Bay Ridge Estates Lot 22 Caron 2023 Replat; KPB File 2022-175 Seabright Surveying / Caron Diamond Ridge Road Diamond Ridge Area / Kachemak Bay APC

#### ITEM 1 - BAY RIDGE ESTATES LOT 22 CARON 2023 REPLAT

KPB File No.	2022-175
Plat Committee Meeting:	January 9, 2023
Applicant / Owner:	Patricia Caron of Homer, Alaska
Surveyor:	Kenton Bloom / Seabright Survey + Design
General Location:	Diamond Ridge Road, Diamond Ridge, Kachemak Bay APC

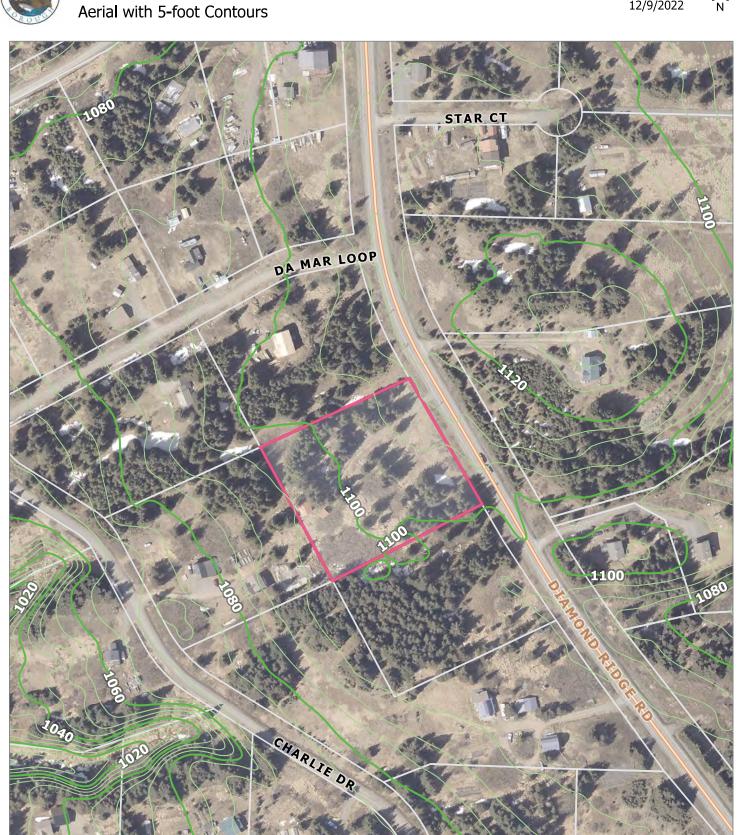
Show recommended 15' HEA easement line and add label or plat note.

HEA	Provide a label or plat note stating, "The existing underground powerline within Lot 22-B is the centerline of a 15-foot-wide electrical easement, including pedestals, granted this plat"
ENSTAR	No comment of recommendations
ACS	
GCI

- On the drawing at the top correct the township accordingly.
- Call out the corner as the ¼ corner.
- In plat note 4, add <u>per</u> in front of the plat reference.

Staff recommendation: Remove "Subdivision" from parent legal description. Update the township.

Staff recommendation: Provide a depiction and label for the lot across Diamond Ridge Road.
